UNITED STATES PATENT AND TRADEMARK OFFICE

APPLICATION NO.	FILING DATE	FIRST NAMED INVENTOR	ATTORNEY DOCKET NO.	CONFIRMATION NO.
09/992,591	11/06/2001	Paul R. Margiott	C-2451	7404

DETAILED ACTION

The present application is directed to a procedure for shutting down a fuel cell and fuel processing system.

FIG. 1

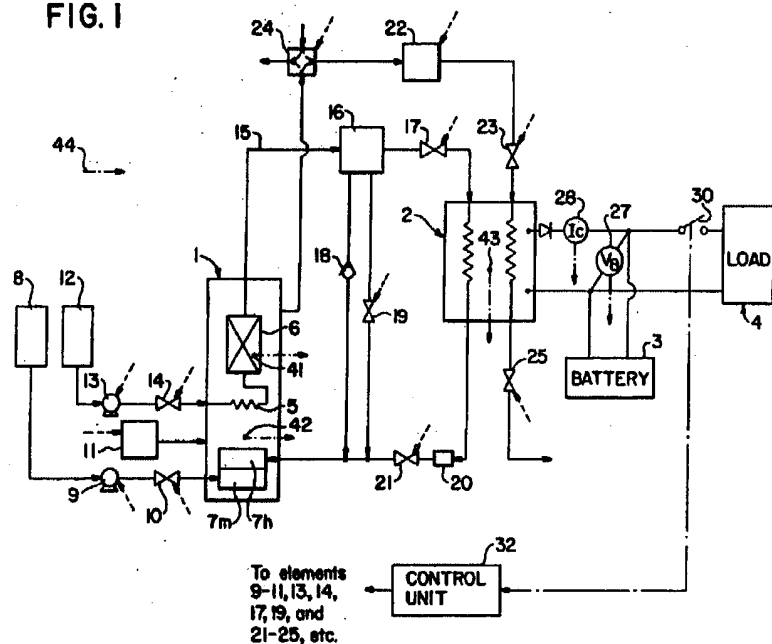
Figure 1 below illustrates the fuel cell processor 1 for generating hydrogen. Connected in parallel to fuel cell 2 is a storage battery 3. A load 4 is connected to both fuel cell 2 and the battery 3 (COL 2, lines 23-31). A fuel tank 8 storing methanol fuel for the burner 7m where it is burned with the aid of air supplied (COL 2, lines 40-48). 7M and 7H also represent burners (COL 2, lines 37-39).

Figure 3 below depicts the shut-down method for a fuel cell system:

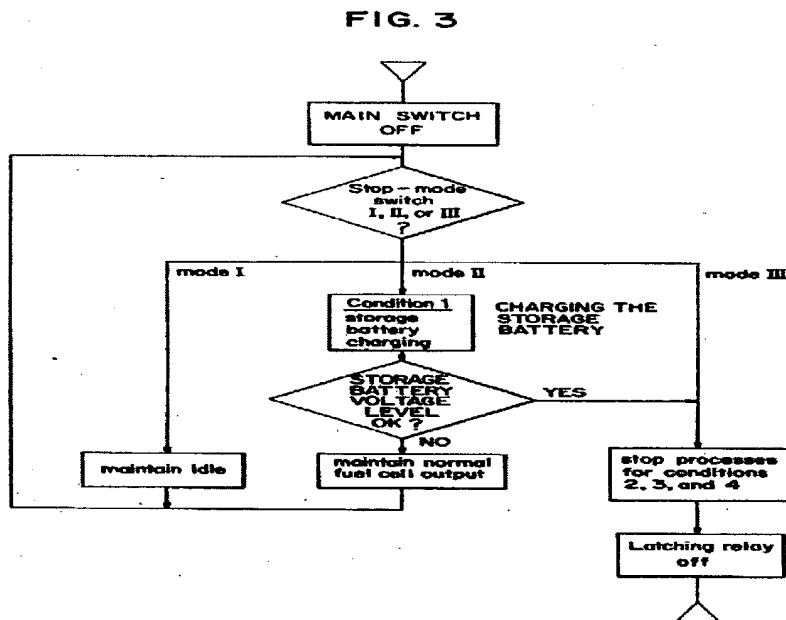
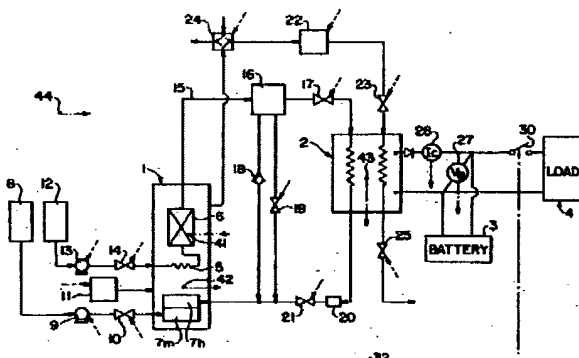
Figure 1 and its enlarged section below shows the fuel cell structure. *It is noted that the top and bottom part of feature 2 represents the two fuel cell ends.* It is also disclosed heating burners 7M and 7H making hot gases (COL 2, lines 35-45). *These burners are in fluid communication with the fuel cell 2.* It is also disclosed that valve 24 is connected thereto, allowing the selection of either low temperature atmospheric air or high temperature air from fuel processor 1 (COL 2, lines 62-67).
